Well Name: CROW FLATS 14 FEDERAL	Well Location: T16S / R28E / SEC 14 / SESE /	County or Parish/State: EDDY / NM
Well Number: 3H	Type of Well: OIL WELL	Allottee or Tribe Name:
Lease Number: NMNM95630	Unit or CA Name:	Unit or CA Number:
US Well Number: 3001536350	Well Status: Oil Well Shut In	Operator: CHEVRON USA INCORPORATED

Notice of Intent

Type of Action: Plug and Abandonment

**Permanent Abandonment of Federal Wells
Conditions of Approval**

**PROPOSED
WELLBORE DIAGRAM**

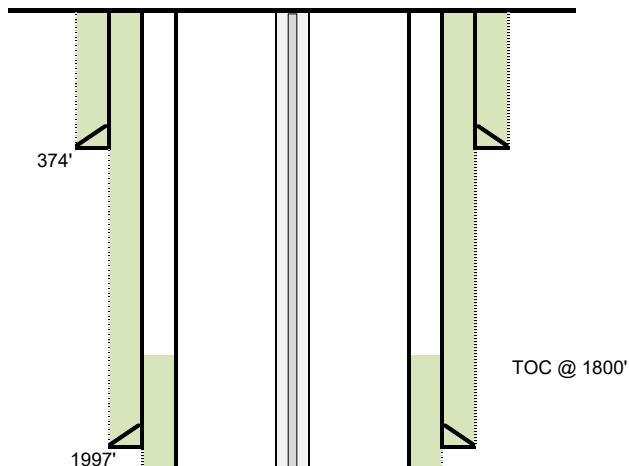
Leak test first barrier to 500psi, 30mins. If CIBP can't be run through liner top or pressure test fails, spot cement from 6359'-6109', set CIBP in the vertical section at KOP and spot 25sx above. Leak test CIBP. Tag and verify at 6109' either way

Leak test first barrier to 500psi, 30mins. If CIBP can't be run through liner top or pressure test fails, spot cement from 6359'-6109'. Set CIBP in the vertical section at KOP. Leak test CIBP. Tag and verify at 6109' either way
